Name of Proposed Subdivision CHANDLERS LANDING - PHASE 17

FILE PLAT					CHANDLERS LANDING ROCKWALL COUNTY, TEXAS
PHASE SEVENTEEN					
DESIGN: R.W.S.	DRAWN: C.P.	SCALE: AS NOTED	DATE: MAR., 1984	SHEET: 1 OF 5	POE & ASSOCIATES OF TEXAS, INC.

RE: Final Plat  
Chandlers Landing - Phase 4 & 17

RE: Chandlers Landing - Phase 17  
ROK 84804

<b>FILE PLAT</b>				
<b>PHASE SEVENTEEN</b>				
DESIGN:	DRAWN:	SCALE:	DATE:	SHEET:
R.W.S.	C.P.	AS NOTED	MAR., 1984	3 OF 5

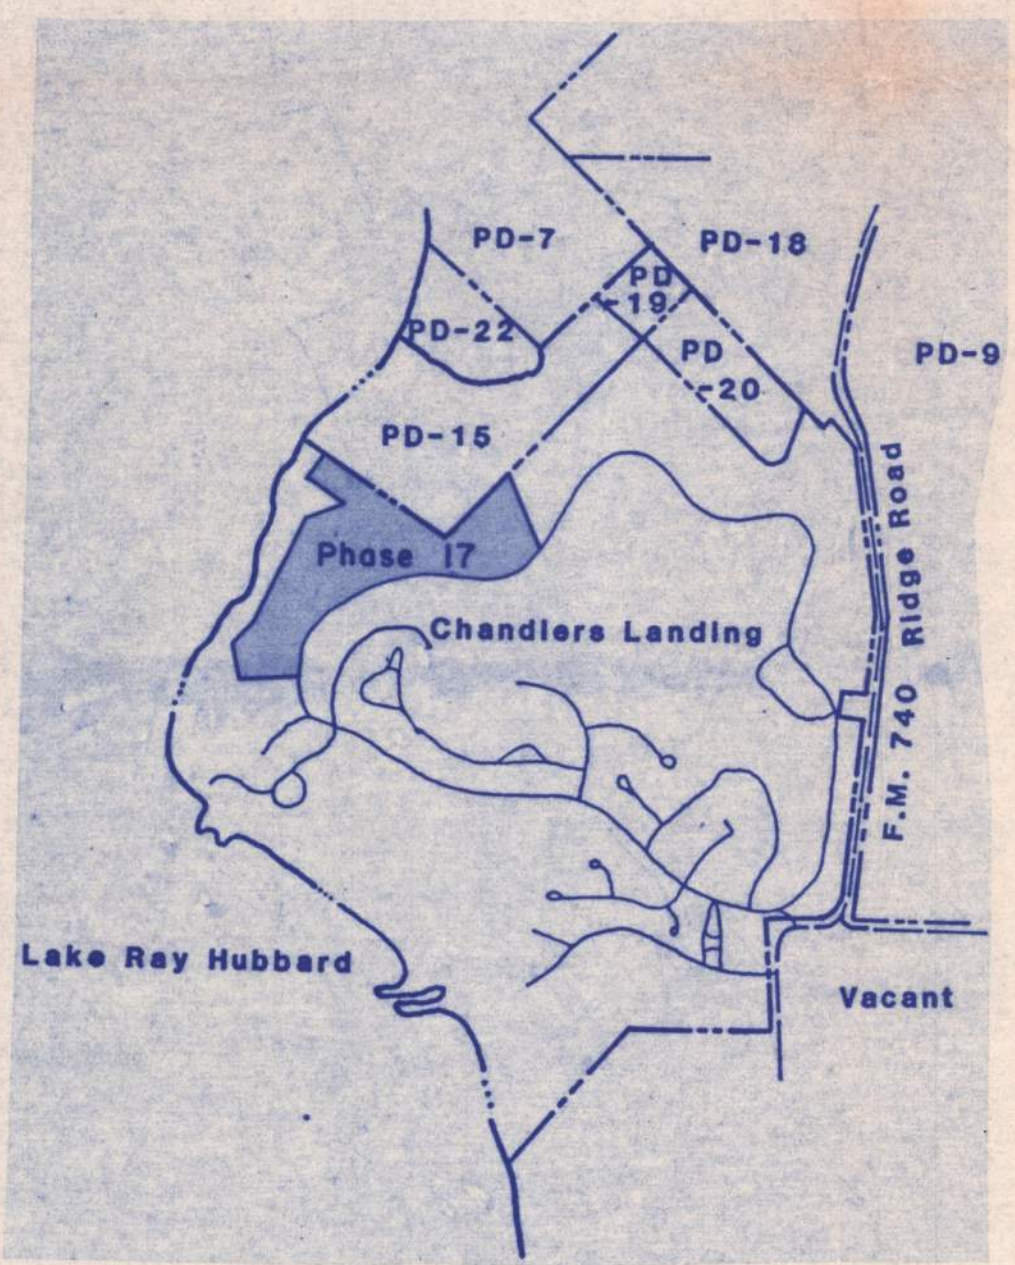
*added two lots from preliminary*
